**REGULAR MEETING OF THE THIRD LAGUNA HILLS MUTUAL
ARCHITECTURAL CONTROL AND STANDARDS COMMITTEE**

**Monday, June 25, 2018 – 9:30 a.m.
Laguna Woods Village Community Center Sycamore Room
24351 El Toro Road**

DATE: June 25, 2018
FOR: Architectural Control and Standards Committee
SUBJECT: Variance Request
Ms. Yu-Hsiung Chen of 3142-A (Las Flores, PL203C, 42)
Room Addition on Back Patio

DATE: June 25, 2018
FOR: Architectural Control and Standards Committee
SUBJECT: Variance Request - Mr. Michael Epstein of 3235-C (La Reina, SB703R_B, 43R) Replace Enclosed Patio with Room Addition

VARIANCE REQUEST
SITE PLAN

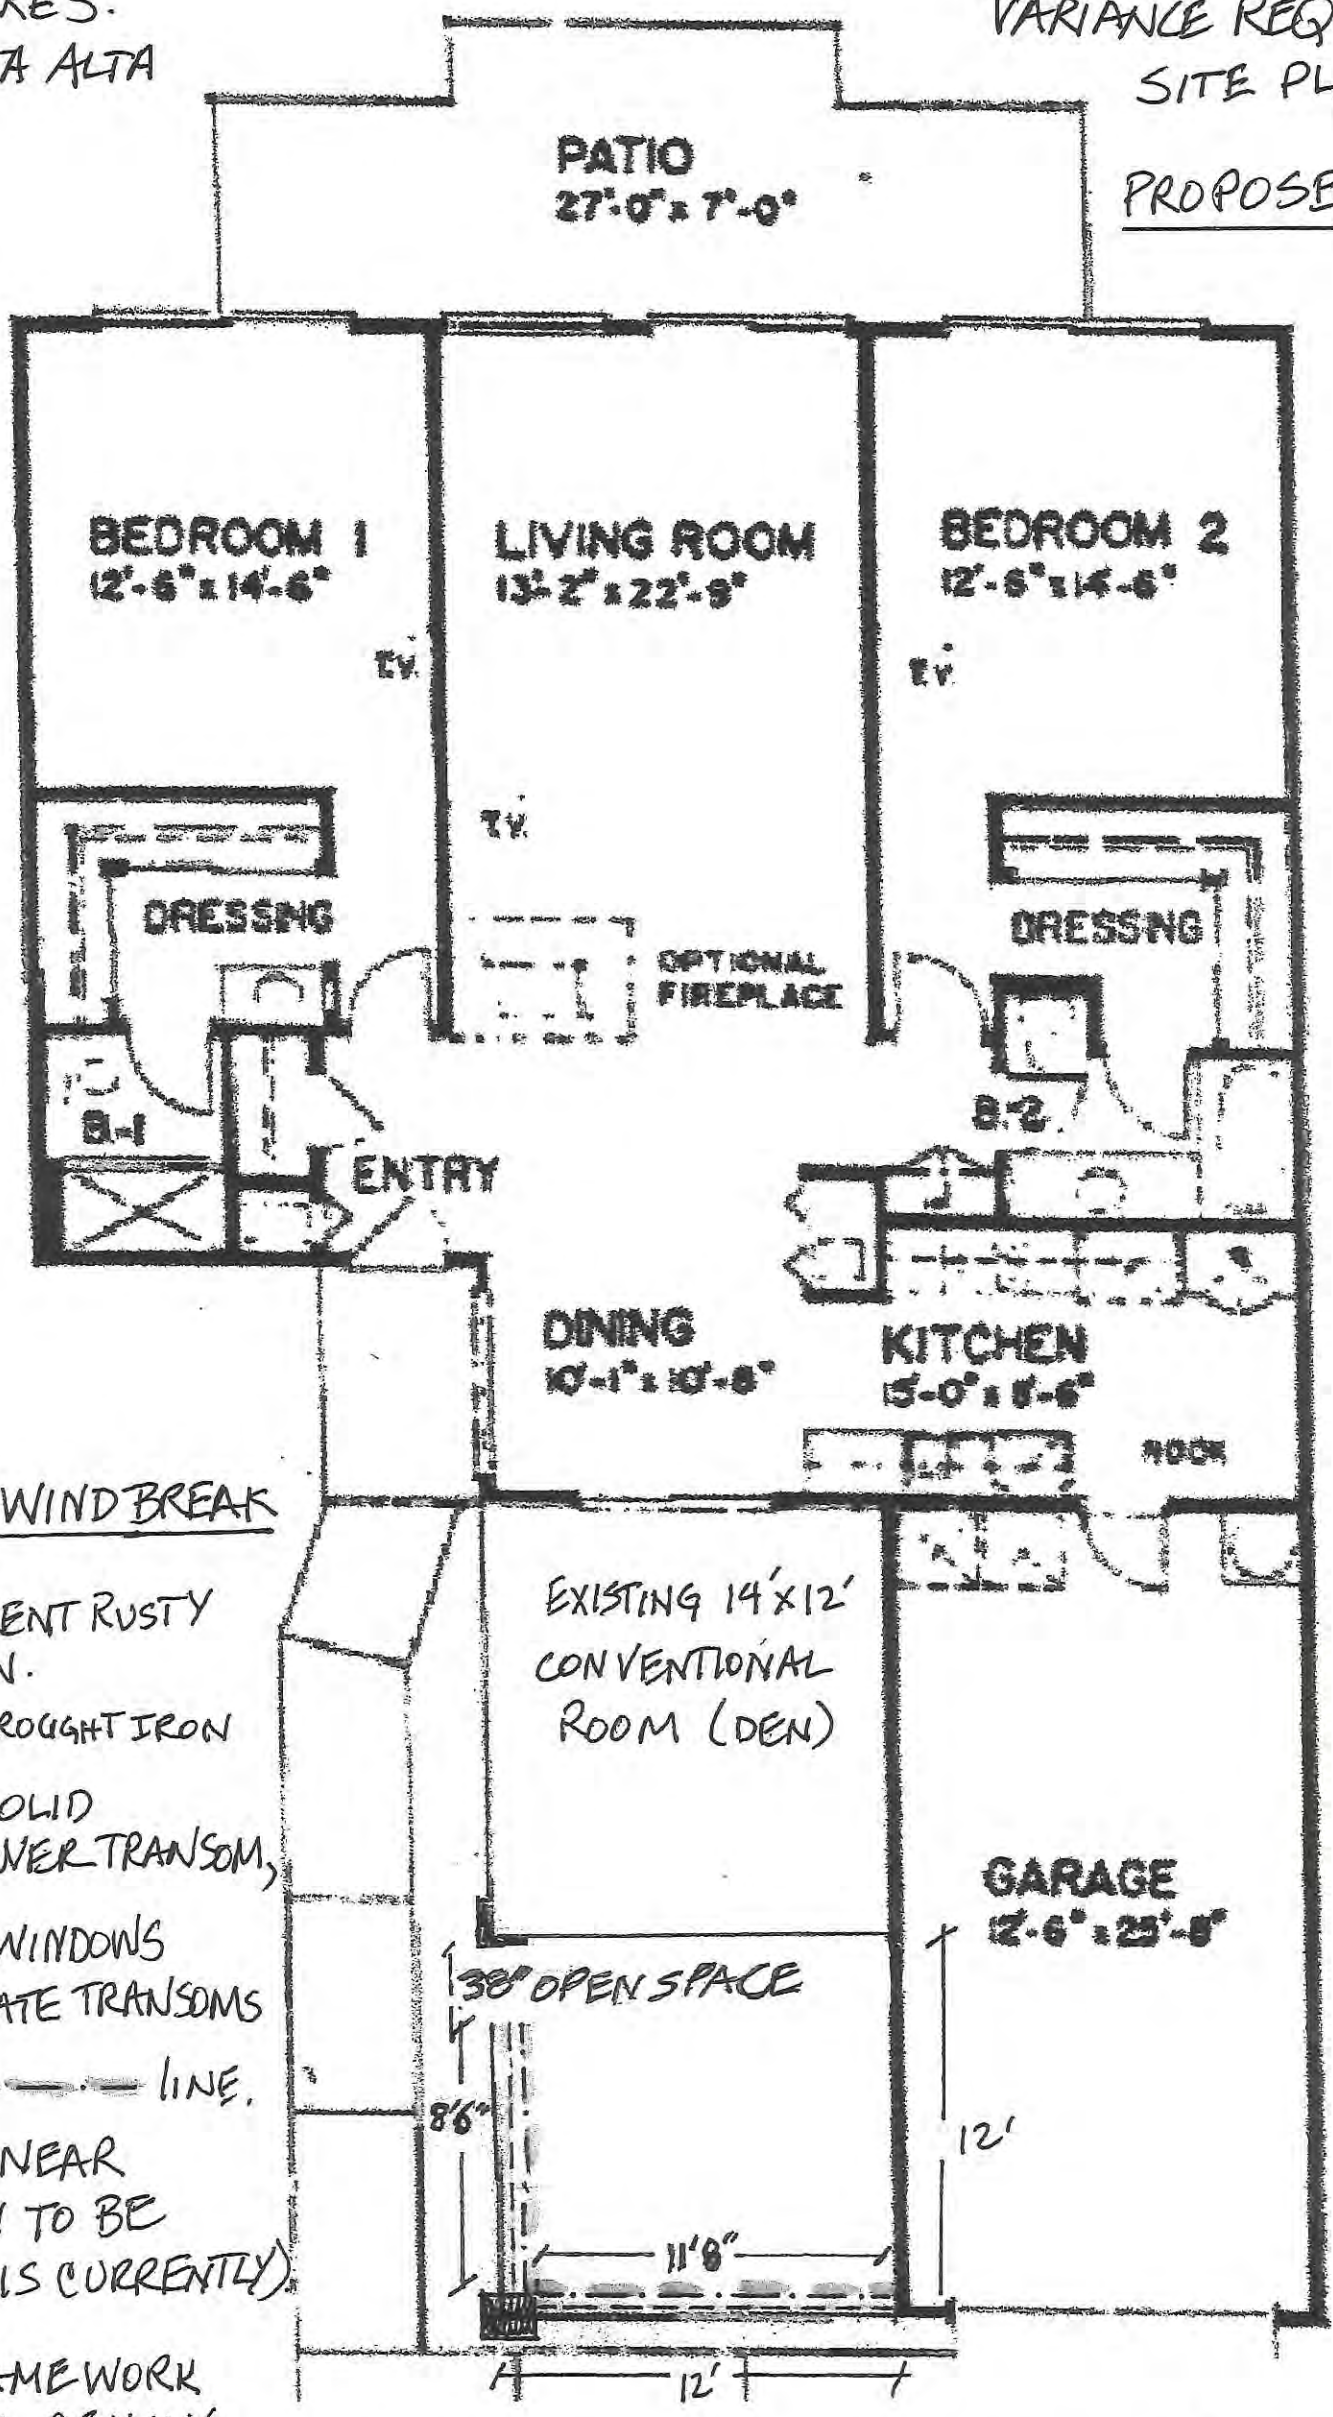
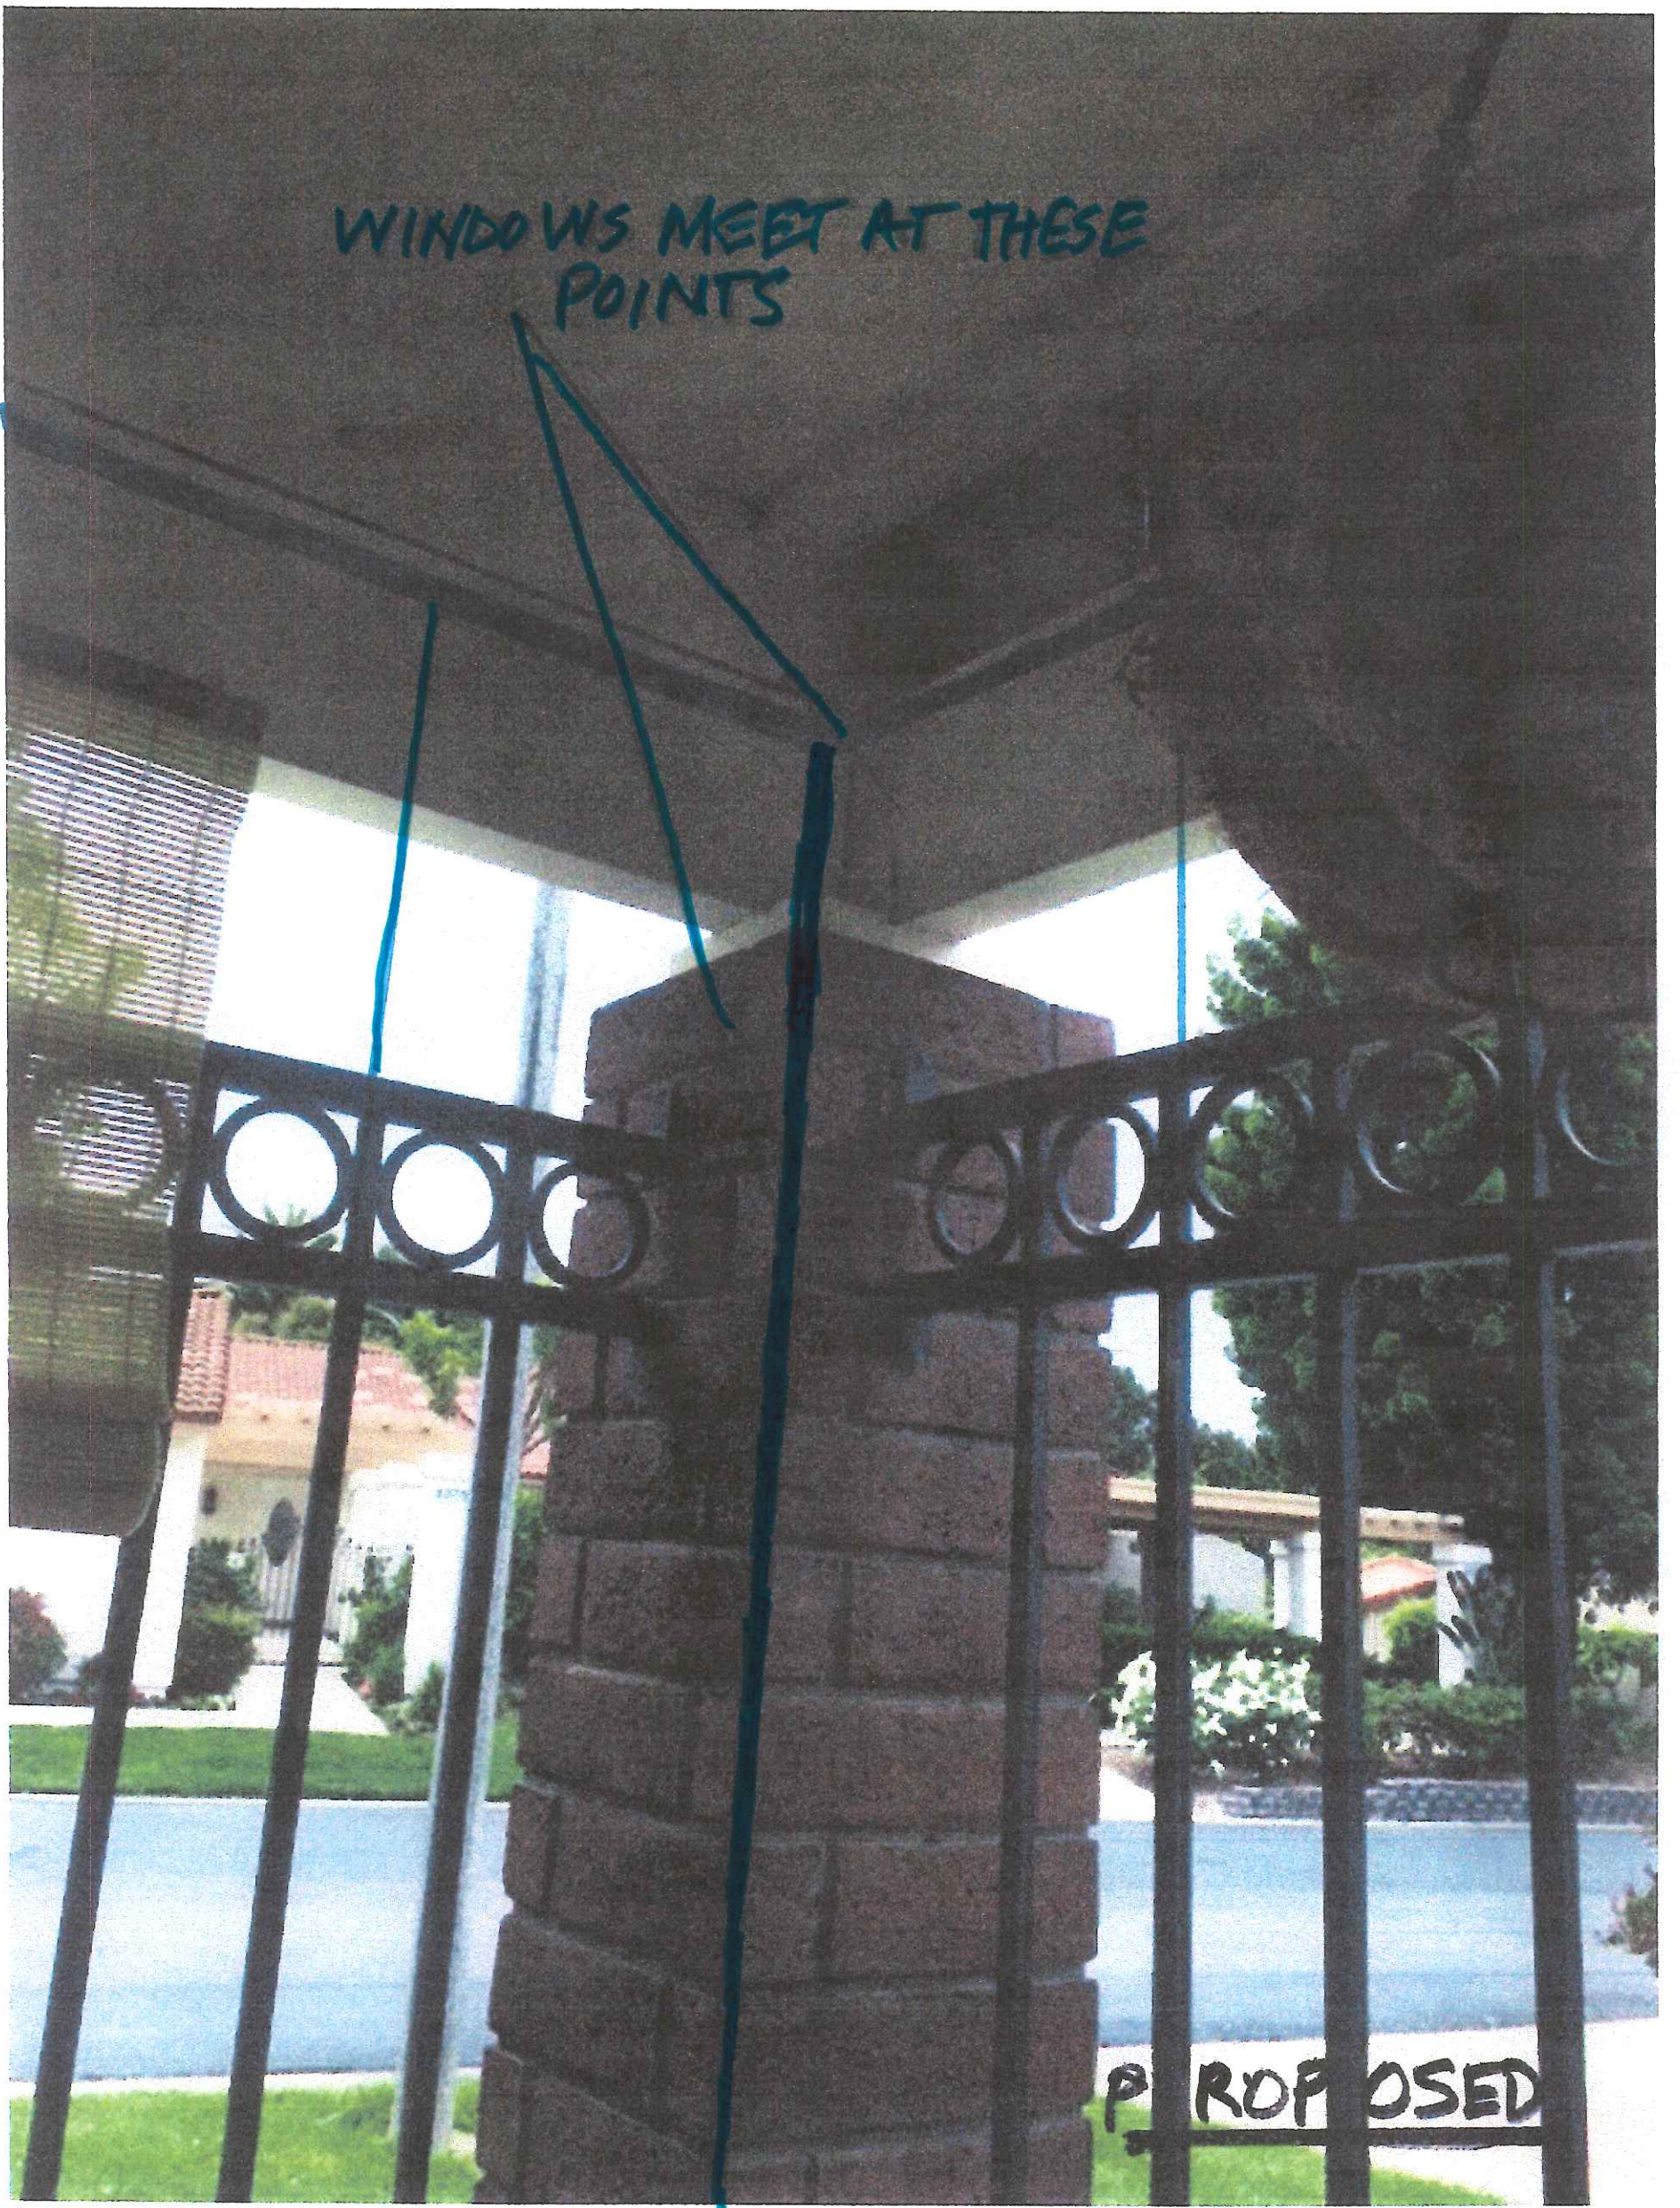
Mr. Cunningham wishes to remove the existing wrought iron fence and install a glass windbreak consisting of a 24" tall kick plate, 42" wide by 60" tall windows and a 7" transom below the existing (original) patio roof.

Staff recommends the Board approve the request to replace the wrought iron fence around the existing front patio with a glass windbreak with the conditions as stated in Appendix A.

Existing Rear Elevation

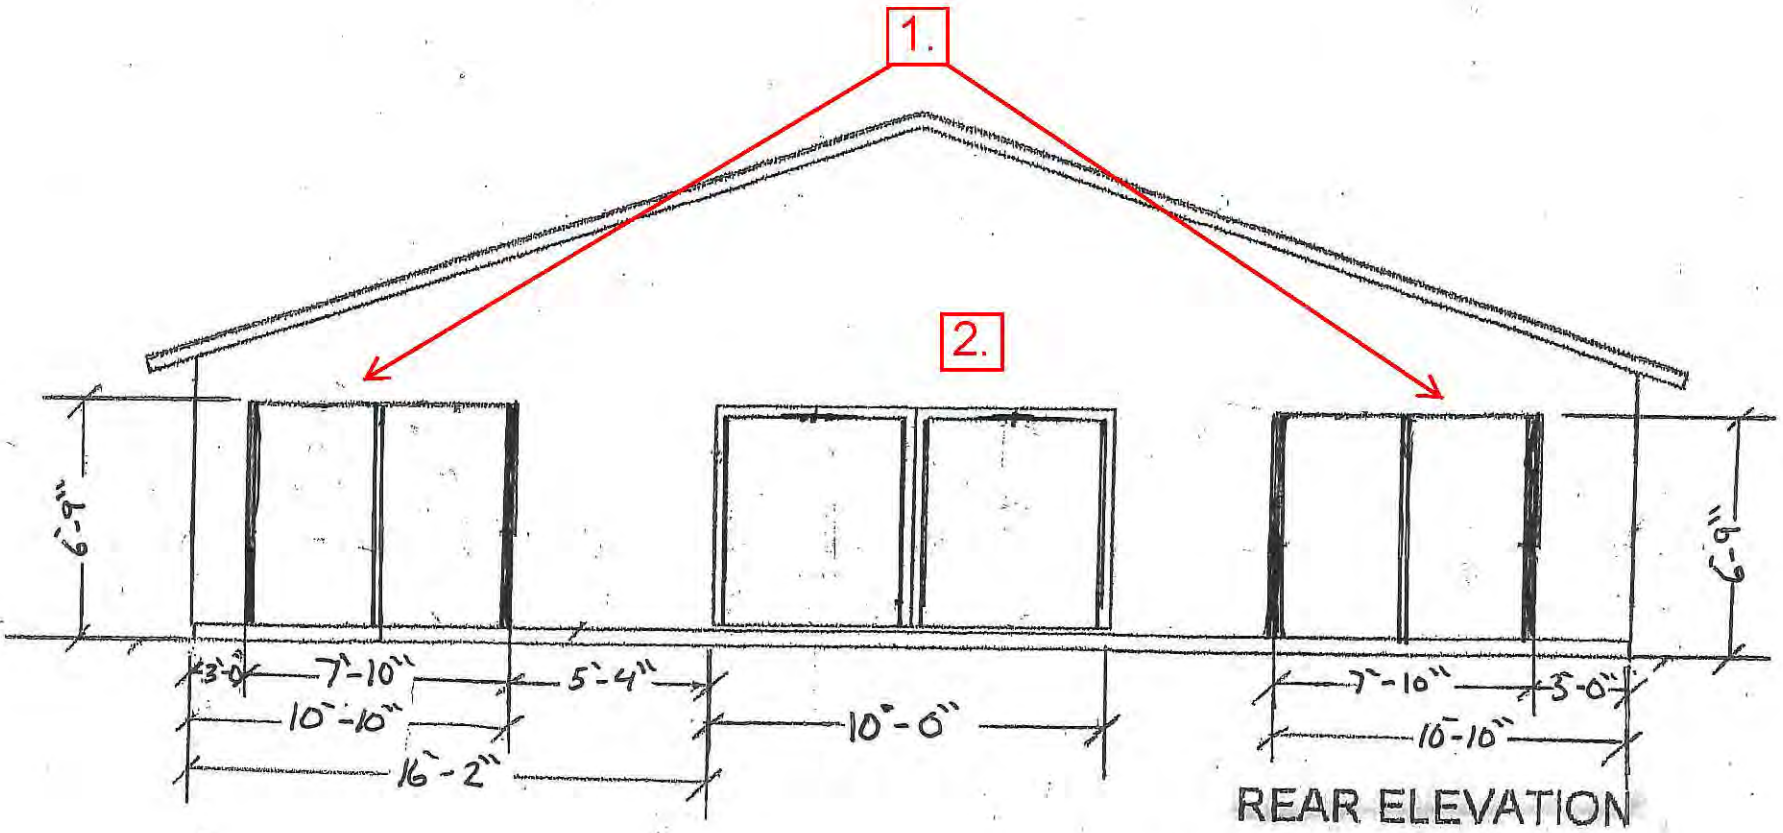
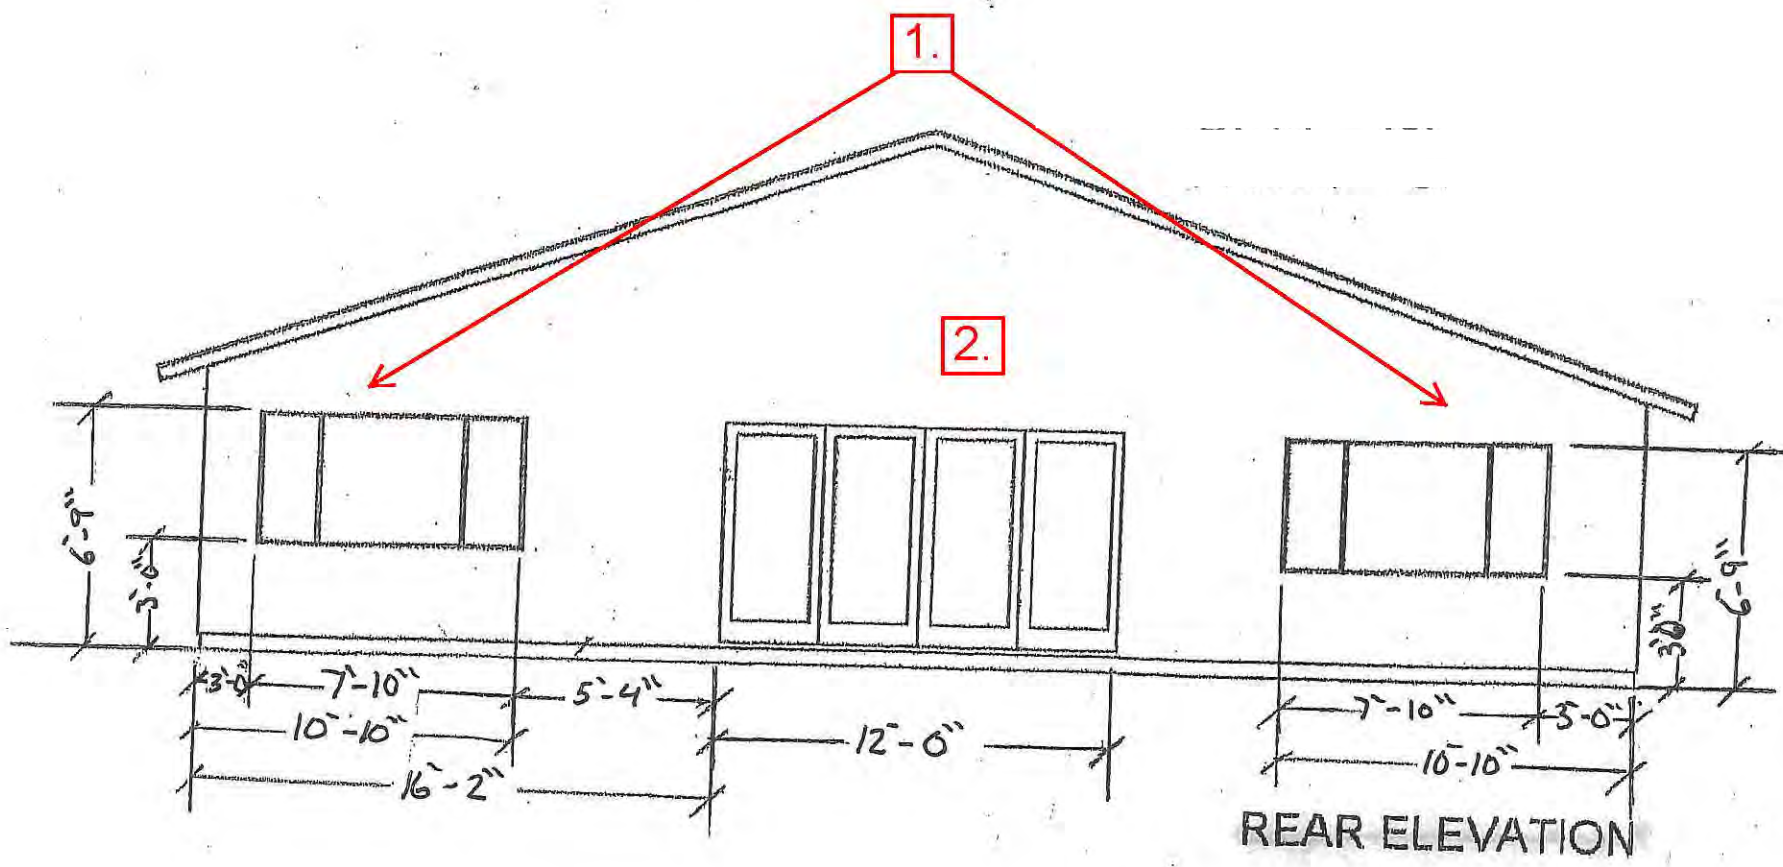
(1) Replace Bedroom Sliding Glass Doors with Windows: Ms. Chen is proposing to remove the original sliding glass doors of both bedrooms (measuring 8' wide by 6'8" tall) and replacing them with white vinyl sliding windows measuring 8' wide by 4' tall. A City permit would verify that necessary requirements of building code are met for emergency egress. Staff recommends approval due to the unit being a stand-alone building and the rear of the property looks over a hill with no direct facing neighbors.

(2) Replace Living Room Sliding Glass Door with French Door: Ms. Chen is also proposing to remove the existing original sliding glass doors of the living room (measuring 10' wide by 6'8" tall) and replace it with a 12' wide by 6'8" French door. Due to requiring a larger

Staff recommends the Board approve the request to Add/Modify Windows and Doors, Room Addition and Bathroom Split with the conditions as stated in Appendix A.
